CAP Aviation 9, rue de l'Aviation 21121 DAROIS - France Tel +33 380 35 65 10 Fax +33 380 35 65 15 www.capaviation.com	S E R V I C E B U L L E T I N	
NUMBER	TITLE	ATA SYSTEM
N° 1	Engine mount inspection procedure	71

Revision	Date	Description	Airworthiness Office Manager	Head of Design Organisation
			Recommendation for approval	Approval
3	15/09/2000	Engine mount type 2 : only type available. Mandatory Service bulletin Inspection reminder

Fig. 1 – TYPE 1
Critical areas to be inspected

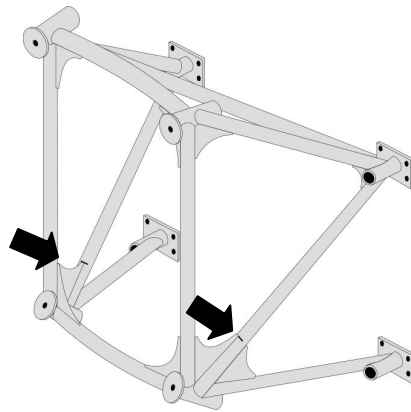
On the lower part of right and left diagonal tube of engine mount, it has been shown that cracks might appear in relation to the more or less heavy use of airplane, in spite of the few improvements of the basic definition.

This type of engine mount is no more available.

Fig. 2 – TYPE 2
Critical areas to be inspected : **at weld bead border at gusset plate end level.**

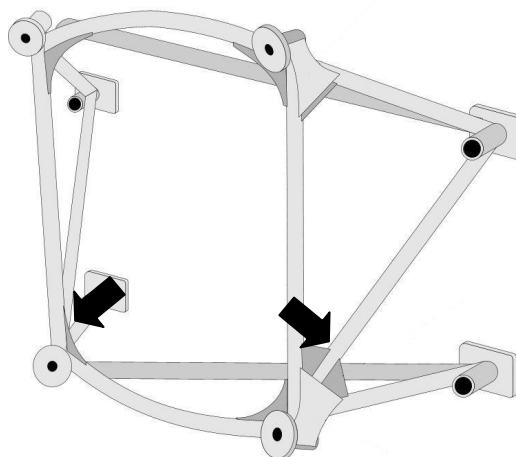
Designed, at first, for CAP 231EX, this engine mount solved the lower part of right and left diagonal tube cracks problem (no crack found in 4 years time on 46 engine mounts in use).

Tube stress relief, due to converging tubes principle, led to dynafocal engine mount cup moving. Consequently, problem occurred in another place : on engine mount first version (Ref. 00), cracks appeared on engine mount cups fixation within 60 to 100 aerobatic hours.

Downward cups have been strengthened (ref. 02 – S/N 17 to 21, and S/N 23 to 40) and then, upward cups (Ref 03 – since S/N 41). Since this last modification, no in use incident has been reported on TYPE 2 engine mounts.

Fig. 3 – TYPE 3
Critical areas to
be inspected.

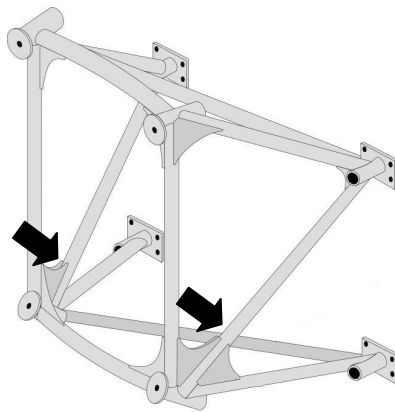
Last version of TYPE 1 engine mount, it takes into account part of TYPE 2 engine mount modifications :

- Diagonal tubes
- Gusset plates moved on tubes exterior
- Vertical diagonal tubes diameter increase

These improvements have not led to TYPE 2 engine mount reliability.
Therefore, TYPE 3 engine mounts are no more available.
